Re: Amendment Request for Ekos at the Preserve #20083, in Irving, Texas

RE: Ekos at the Preserve (TDHCA # 20083)
Application Amendment
Texas Housing and Community Affairs
221 E. 11th st, Austin, TX 78701
FK Project No. 5637

RE: Correction Explanation to 2020 Architect Certification Application

CLUBHOUSE FLOOR PLAN
SCALE: 3/16" = 1'-0"

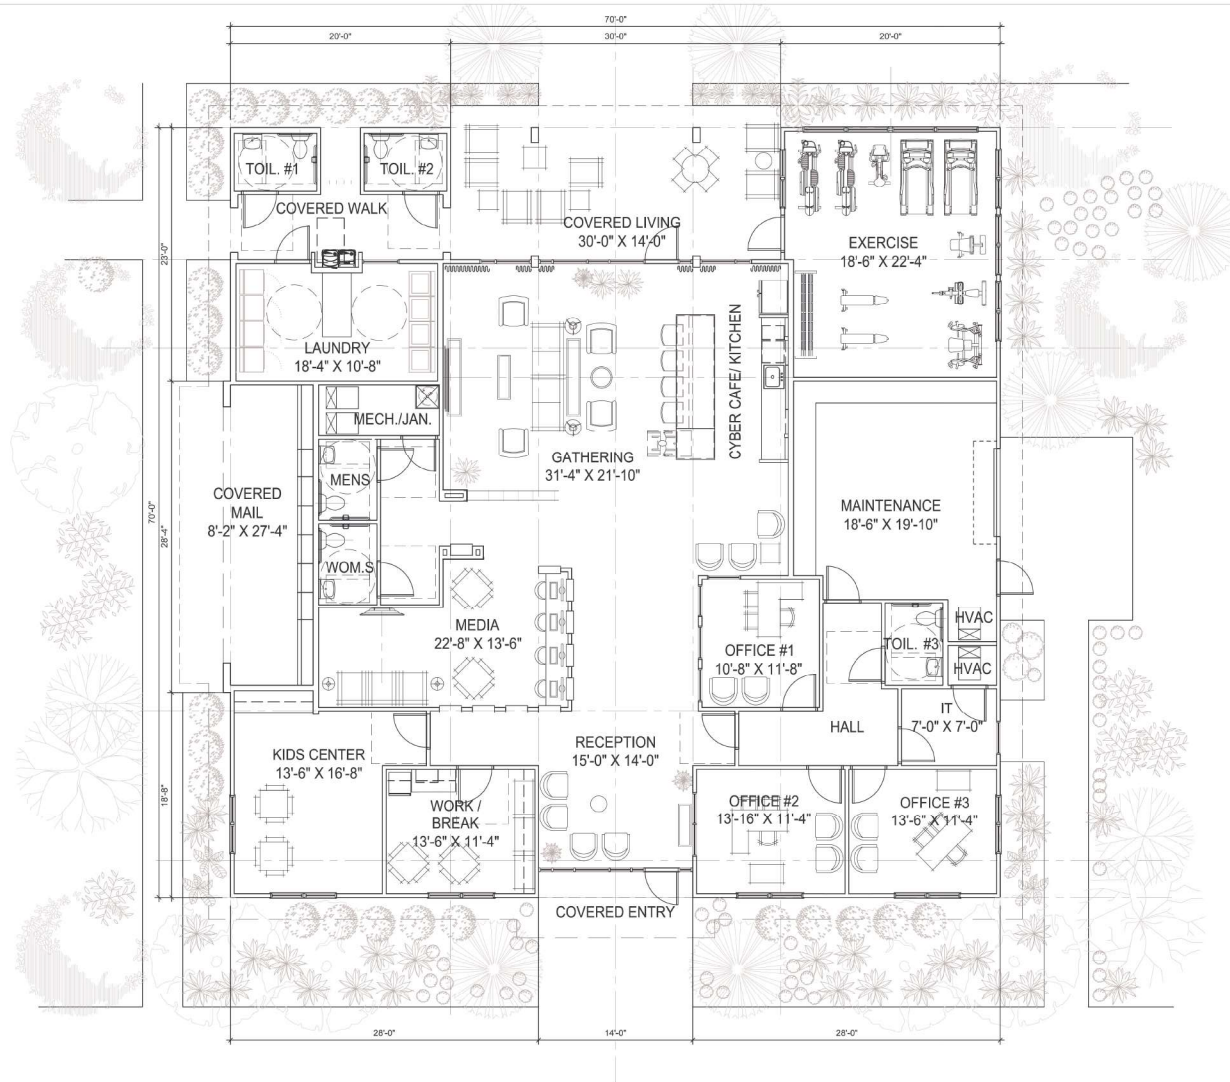
The original clubhouse calculations included the maintenance area as part of the common area square footage, kids play center, and laundry room. On 9/9/20, at the request of the client, the clubhouse was redesigned due to site constraints, which reduced the overall square footage of the building. We accomplished this reduction by removing the interior kids play center & laundry room from the clubhouse and relocating them. The kids play center was relocated from an interior conditioned space to the exterior near the pool area. The laundry room was also removed from the clubhouse and replaced with laundry closets in all unit types. As for the apartment buildings, the original layout contained a center corridor on every level that ran horizontally through the building connecting the open stairways. This was removed from every level in all building types, which had an impact on the non-rentable area square footage numbers. The corridors were originally designed due to site constraints adjacent to the natural wetland area. Later, as the civil engineer was more involved it was determined that preferred conventional cross-breezeway buildings could be utilized.

These are the areas enumerated on the Common Area calculation sheet.
